Public Comment No. 16-NFPA 780-2015 [Global Input]

Public Comment No. 56-NFPA 780-2015 [New Section after 1.6]

Figure 4.8.2.3(b) Lower Roof Protection Provided by Pitched-Roof Buildings 25 ft (7.6 m) or Less in Height.

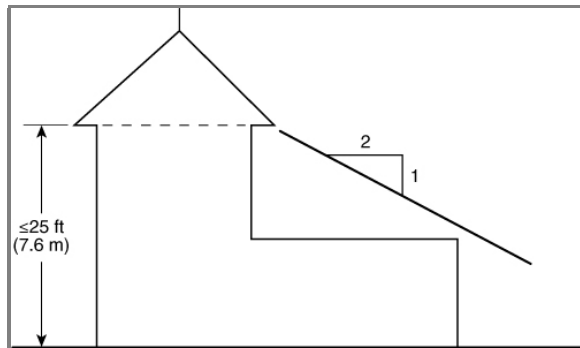
Figure 4.8.2.3(b) and its caption implies an interpretation of the standard that is not identified anywhere in the standard, Annex, or the handbook for the standard. The committee statement for PI-17 identifies that protected roof levels provide a zone of protection for lower roof levels in accordance with Paragraph 4.8.1. Section 4.8.1 only lists 3 ways to determine the zone of protection and indicates they may be used in combination. Nowhere in any of the sections does the standard indicate that a part of the structure protects another part of the structure unless that part is within the zone of protection provided by a strike termination system. While the requirements of 4.7 allows the ridge conductor to protect the eaves, it does not protect the projected wing below unless that wing is within the zone of protection of the air terminals on the ridge using either the protective angle or rolling sphere method. Clause 3.3.45 defines Zone of Protection as the space adjacent to a lightning protection system that is substantially immune to direct lightning flashes. Clause 4.7 defines the protected area by the placement of strike termination devices. Clause 4.8.2.2 identifies the zone of protection is defined as an angle from “the strike termination device” and Clause 4.8.3 describes the zone of protection is the volume where a sphere is tangent to earth and resting against a strike termination device or supported by two or more strike termination devices. The only place in the standard where a zone of protection is indicated to be from a part of the structure that neither serves as a strike termination device nor has one installed at that location is in Figure 4.8.2.3(b). This appears to be in violation of the Manual of Style so the figure should be deleted or revised.

Statement: The Technical Committee revises the figure to re-dimension the building height in accordance with 4.8.2.3.

Figure 6.1 Heavy-Duty Stack.

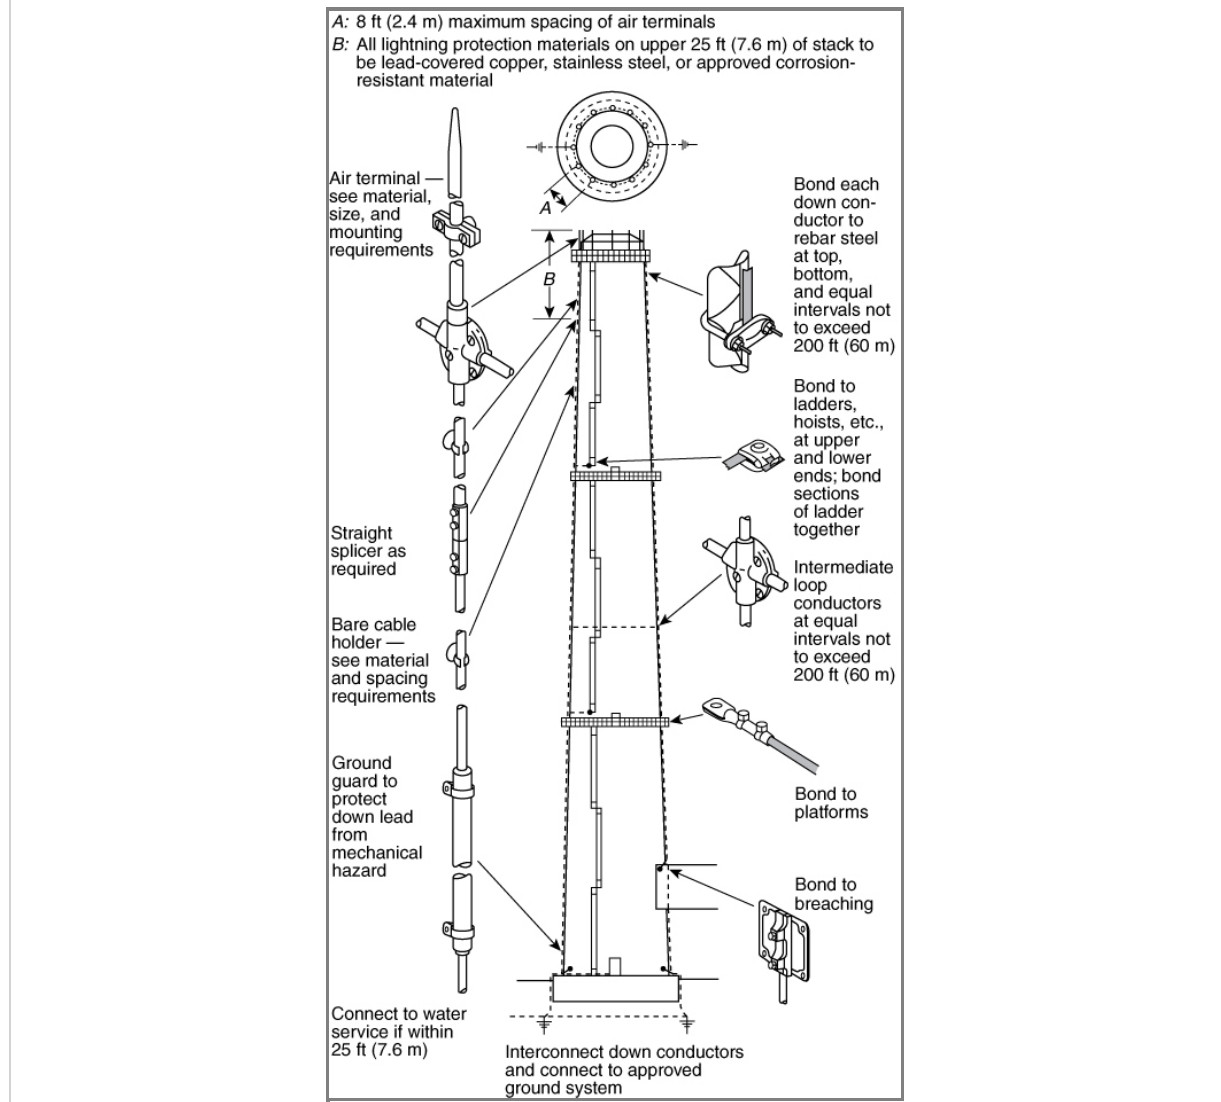
A smoke or vent stack as shown in [Figure 6.1](#) shall be classified as heavy duty if the cross-sectional area of the flue is greater than 500 in.² (0.3 m²) and the height is greater than 75 ft (23 m), above ground level grade level .

Statement: The Technical Committee uses the term "grade level" to clarify the requirement.

Figure 12.2.2(b) Typical Adjacent Mast Arrangement to Provide Zone of Protection for Solar Array.

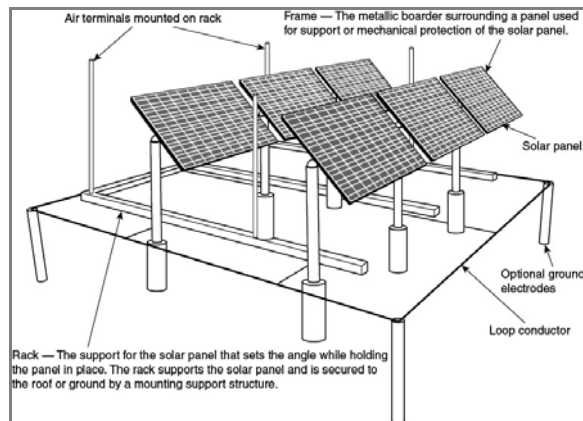
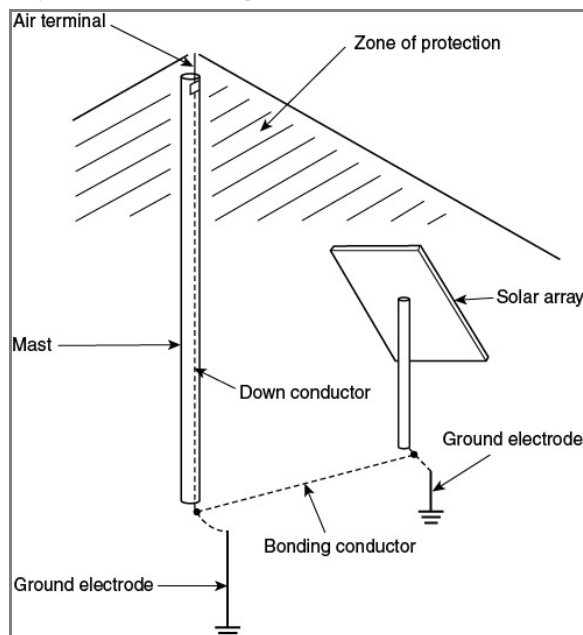
Additional annotation to the figure to note that this is also an NEC 690 requirement. Also a request to improve the figure to show the rack location higher to just beneath the modules and for the bonding to the ground loop be

Statement: The Technical Committee updates the figures and corrects a typo. The Technical Committee adds a note to Figure 12.2.2(b) to reference NEC 690.

Figure K.3 Depiction of a Roof Level PV Installation Showing Typical Lightning Current Distribution Among Current Carrying Conductors and SPDs. (Source: modified from IEC 62305-4, Protection Against Lightning — Part 4: Electrical and Electronic Systems Within Structures, edition 3.)

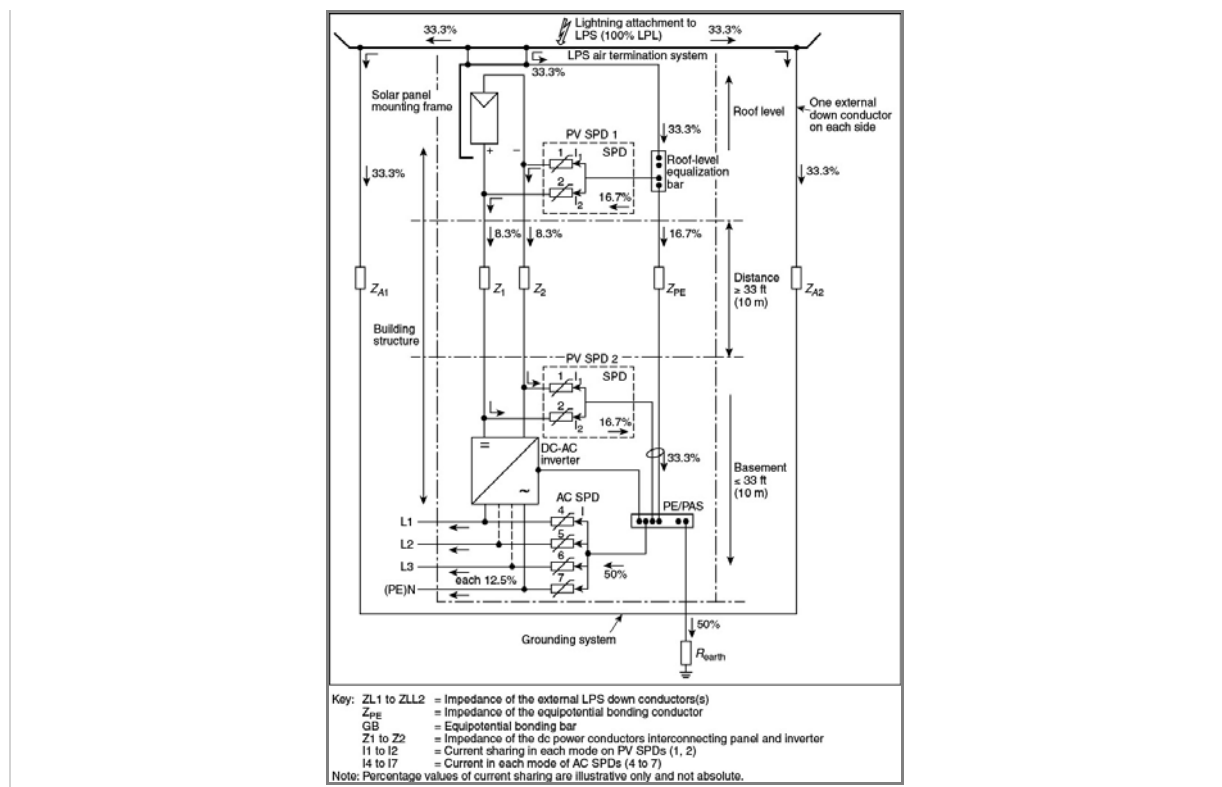
Figure K.3 depicts a current sharing concept between the lightning protection and photovoltaic systems and how this impacts on the various SPDs installed.

Statement: The Technical Committee edits the second paragraph because it adds clarify by using terms that are familiar to NPFA 780.

Figure L.6.6.1.2 Collection Areas (A_D , A_M , A_L , A_{DJ} , A_I). (Source: IEC.)

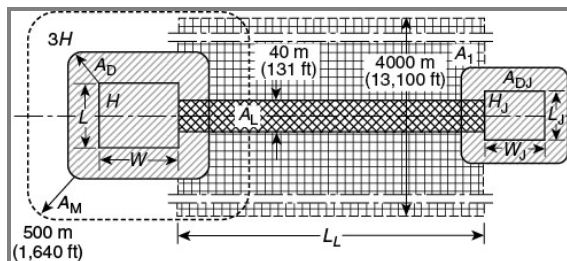
Two typos were identified in the Figure L.6.6.1.2 from the figure from the public input. This comment corrects the typos.
